24 September 2018

**BUILDING CODE OF AUSTRALIA ASSESSMENT
1 KENSINGTON STREET, CHEPPENDALE**

We have assessed the architectural plans for internal alternations at the above mentioned premises for compliance with the Building Code of Australia (BCA) 2016 Amendment 1. The following main BCA issues associated with the proposed building work have been identified.

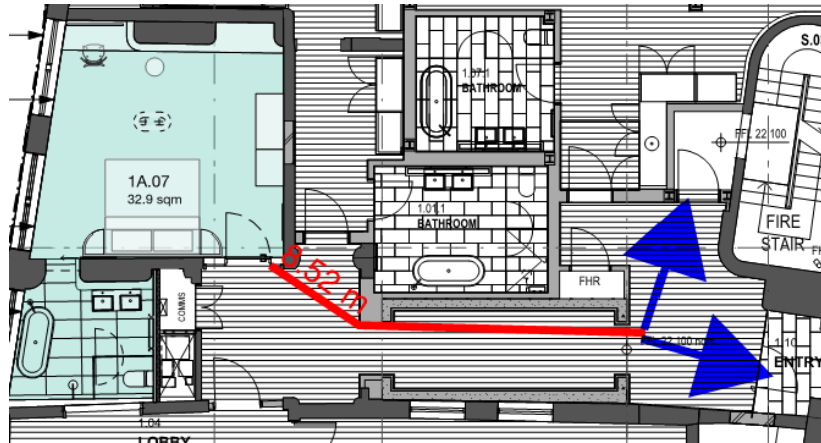
4.7 The location of the fire separation between the boardroom and the common corridor is required to be established. If the airlock is part of the common corridor (not fire separated from main corridor), then the minibar must not be located within the airlock.

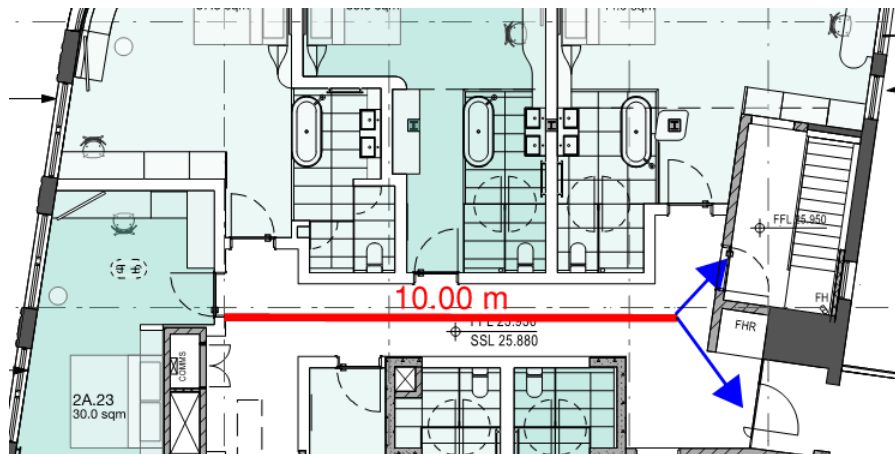
- 5.1 Hotel room 1A.07 on Level 1 will have a travel distance, from the unit entry door to a point of choice, of 8.5 m, which is more than the 6 m permitted by BCA D1.4 .

The existing FER for the building justifies extended travel to a point of choice of up to 8 m from this area of the building. The extended travel distance of 8.5 m on Level 1 is required to be performance justified.

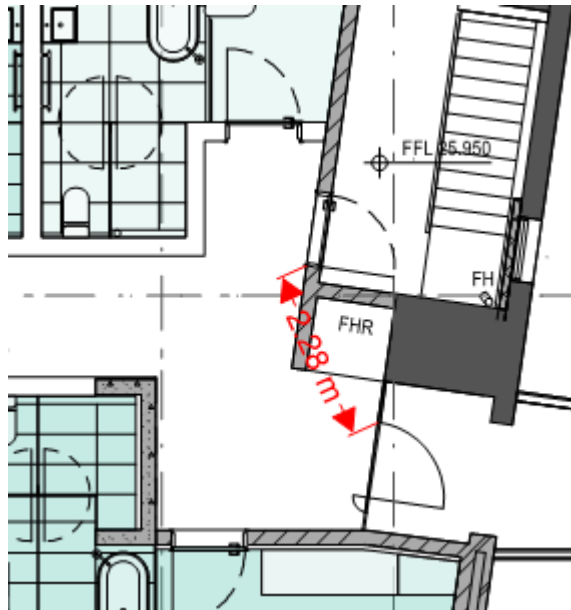
On Level 2 the new rooms have a maximum travel to a point of choice of up to 10 m.

The extended travel distance of 10 m on Level 2 is required to be performance justified.

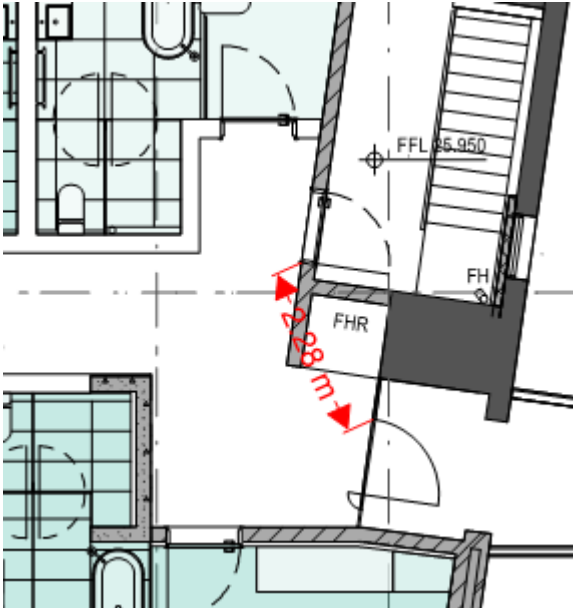
D1.5	Distances between exits	<p>The distance between alternative exits (S.03 and the central stair) on Level 2 is 2.28 m which is less than less than 9 m minimum specified in BCA D1.5.</p>  <p>The existing FER for the building justified reduced distance between exits of 3.4 m on Level 1. The reduced distance between exits on Level 2 is required to be performance justified.</p>
F2.4	Access to accessible sanitary facility by Heritage boardroom occupants in function mode	<p>The occupants of the heritage boardroom, in function mode, will rely on access to the accessible bathroom within room 2A.16 via a management in use plan. This will be the subject of a performance solution.</p>
